## MODEL 460 ADDENDUM

Due to an improvement in the CRT it is necessary to use a higher accelerating voltage.

If you have the 460 Kit please make the following changes in the Construction portion of your manual:

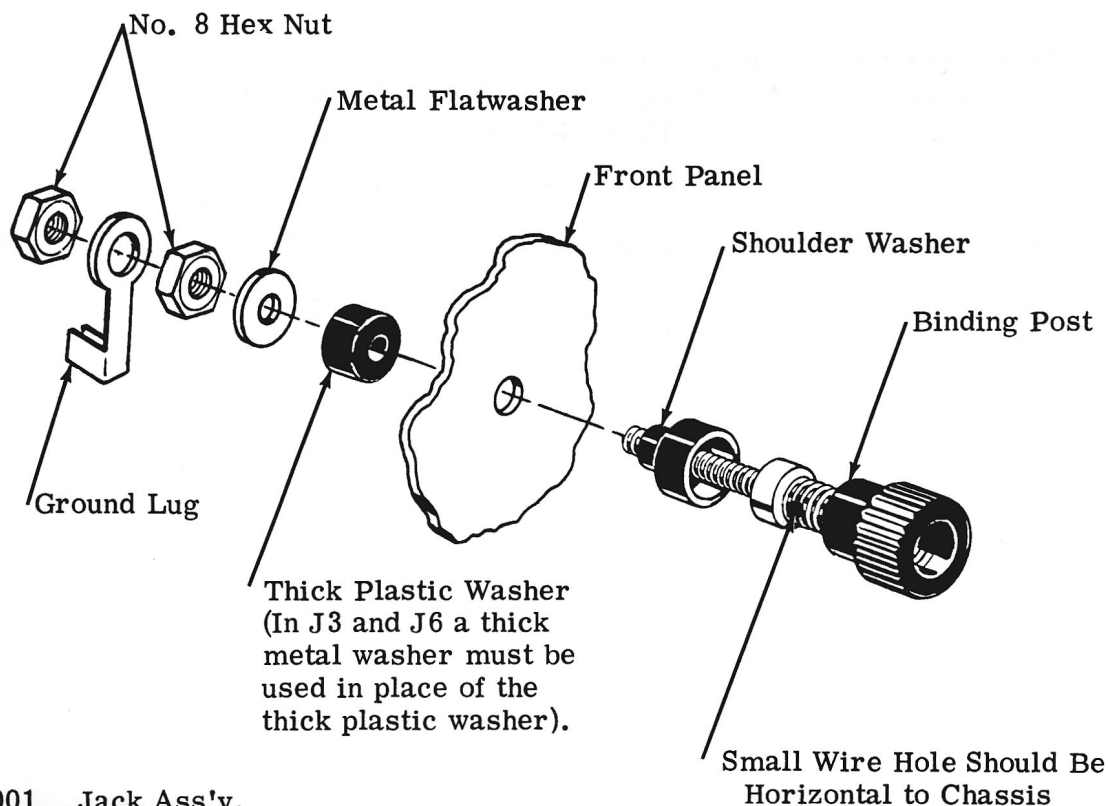
- 9) Fig. 12. Change the wire from R72-2 to read TB8-2 instead of TB-2.
- 10) Fig. 7. Change R24 from "2.5K $\Omega$ " to "5K $\Omega$ ."
- 11) Front Panel Ass'y. (Figure 7) Steps 2 & 4 USE THE PROCEDURE SHOWN WHEN MOUNTING ALL JACKS
